S E R V I C E N O T E

HP 4992A NodeLocator

Modification to fix "Node Movement" or "Node Hopping," and Network performance (throughput) problem.

04992-66503 NodeLocator Main Board Assembly

Pictorial: 4992A R2 and R16 Location

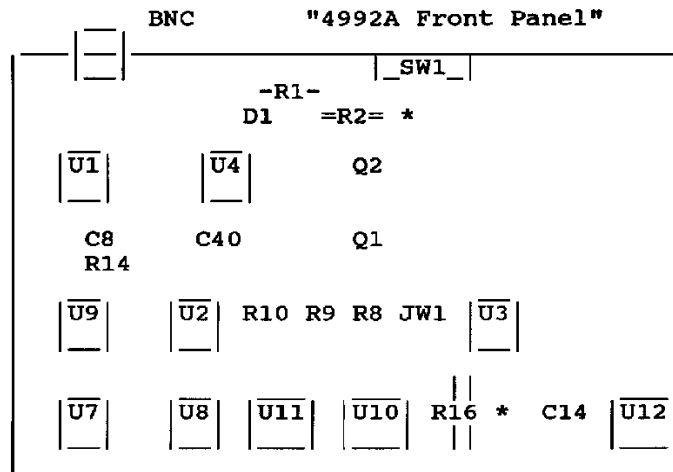
The modification is to lower the echo pulse amplitude and to modify the HP4991A amplifier to accept the new pulse which will not affect the network performance.

1. Locate and remove R2. Replace R2 with 0757-0395 56.2 ohm.
2. Locate and remove R16. Replace R16 with 0698-3153 3.83 K ohm.
3. Remove old board label and replace with new board label (new label has new date code).
